**COACH MODEL :** CX 35 and CX 45  
**DATE :** November 20 2022  
**SUBJECT :** Wiring Modification when replacing complete mirror assembly

The diagram below shows the factory plug on the left and the modified plug on the right .

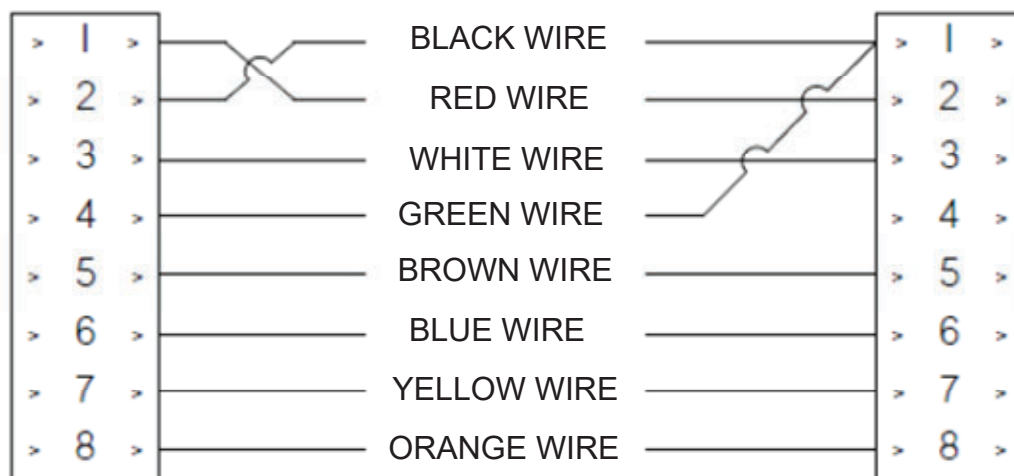
Older coaches use a 3-pin control for the mirrors and the new mirrors use a 4-pin control setup. In order to remedy this, the 8-pin plug on the coach side must be rewired as follows:

Remove Pins 1,2, and 4 (should be red, black, and green wires, respectively)  
 Cut off the terminals of pins 2 and 4.  
 Crimp wires from pins 2 and 4 together into a new pin and insert into pin 1.  
 Insert wire from pin 1 into pin 2.

Moving forward, a plug and play adapter harness will be provided with a new mirror purchase. When replacing the mirror simply install the harness shown below to avoid wiring modifications. The adapter harness is not available separately.
